**AUSTIN ROVER**

**BULLETIN**  
**MONTEGO** **TECHNICAL**

**Item 26**

**Item 27**

fig. 26/1

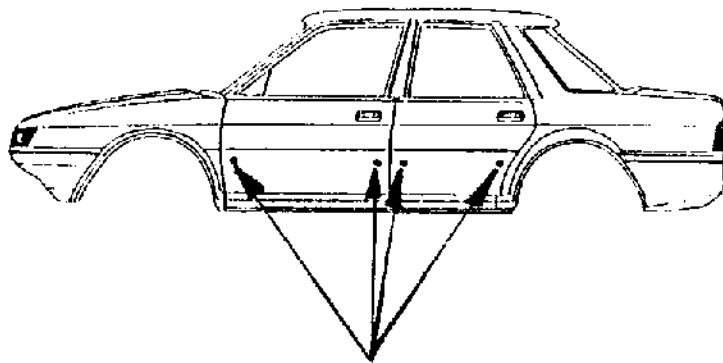
Spot welds visible adjacent to front and rear edges of side doors on cars to which rubbing strips (supplied with the car) are to be fitted.

As these welds are directly in line with the fitting position for the strips and are completely covered when these are fitted, it has been deemed unnecessary to undertake any re-working and no claims will be accepted for such re-work.

fig. 27 1

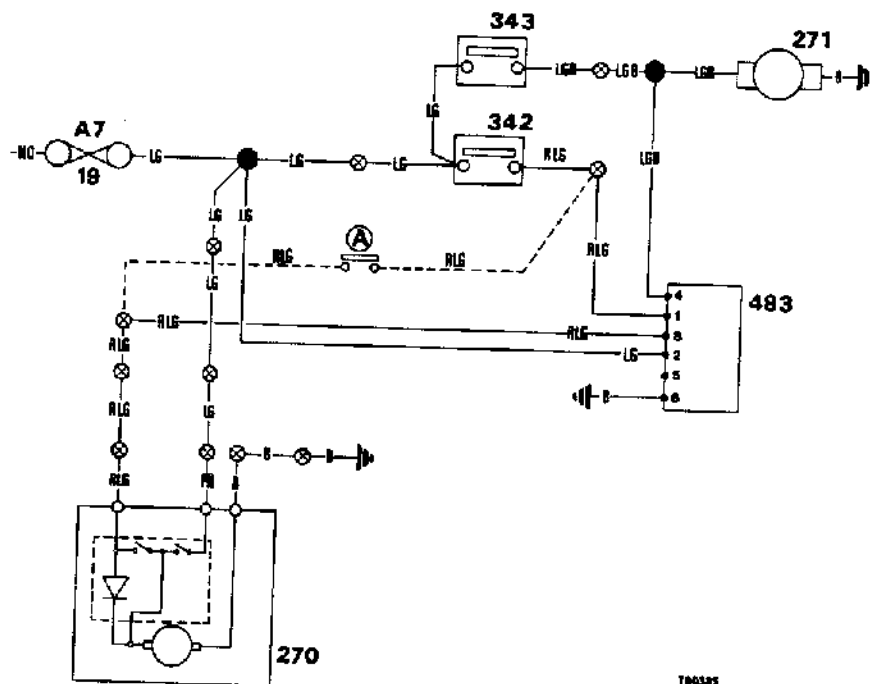
Requests for the provision of continuous rear wipe or automatic operation in reverse gear have been received from some customers.

Whilst no specific recommendations are being made it should be noted that this can be provided by installing a simple "on-off" switch to connect together the two red/green leads (pin 1 and pin 8) of the rear wiper programme unit. The connections required are shown as dotted lines at "A" in fig. 1. (Wiring colours and other items are as in the supplementary diagram in the repair manual.)

When the switch is in the "open" position, programmed wipe with delay is provided. When the switch is "closed", continuous wipe will be available whenever the fascia panel rear wiper switch is operated.

fig. 27/2

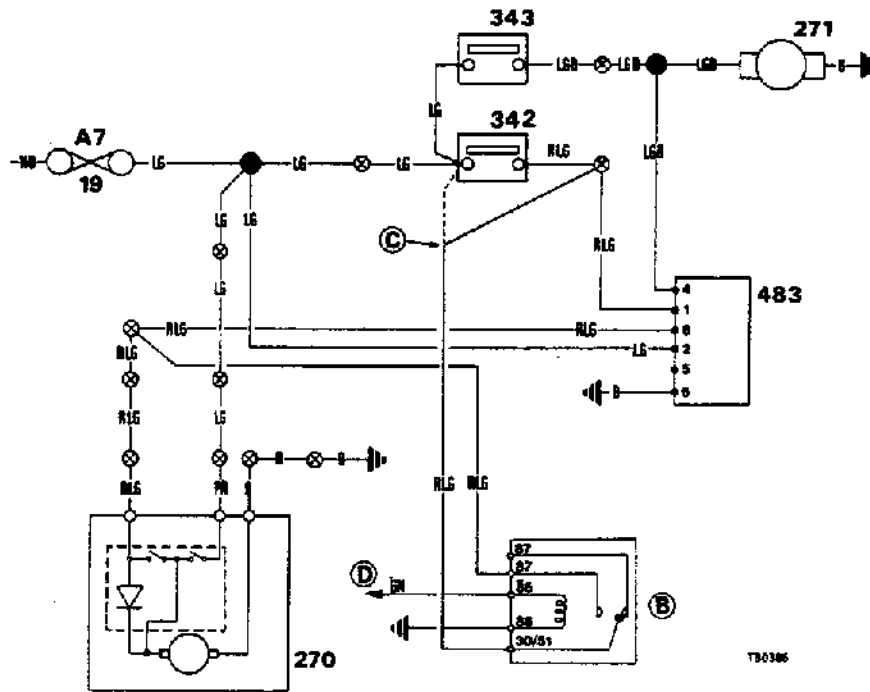
It is also possible to provide automatic rear wiper operation when reversing by installing a standard 4 pin relay, with its windings connected across the reverse

lamp circuit, to join the red/light green wires, as above - see fig. 2.

This will provide intermittent operation of rear wiper when reverse gear is selected, irrespective of the position of the fascia panel control switch.

Alternatively, by connecting the common terminal (30/51) of the relay to the light green wire of the fascia switch (as shown dotted at "C") continuous rear wiper operation when reverse gear is selected can be obtained. In both instances, relay winding feed (terminal 85) - "D" in fig. 2 should be connected to the reverse lamp circuit.

fig 28.1

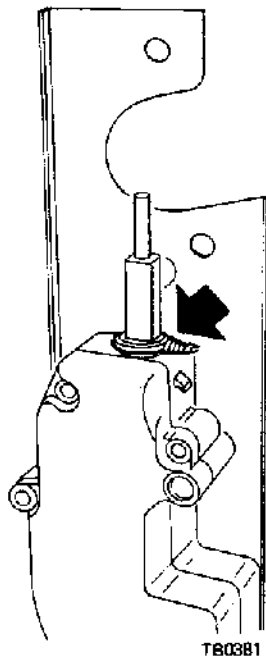
Central door locking fails to operate on boot or tailgate locks.

Motor driven locking plunger partially withdrawn from lock due to "bounce back", allowing locking mechanism to disengage.

Since the fitting of these devices to an existing lock/motor assembly is impractical, where a customer complains and the condition is found to be caused by motor "bounce back", the following action should be taken:

- 1 Remove lock and motor assembly (refer to repair manual).
- 2 Ensure that slots in motor casing through which square nylon plunger carrying locking bolt emerges are free from moulding flash.
- 3 Using suitable soft iron wire, apply one turn in groove of motor casing, twisting wire ends together,

as shown.

- 4 Using flat nosed pliers, continue to twist wire ends together until a slight restriction of plunger movement can be felt.
- 5 Cut off surplus wire, ensuring that any remaining cannot foul any part of mechanism.
- 6 re-assemble lock and motor and test for correct operation.
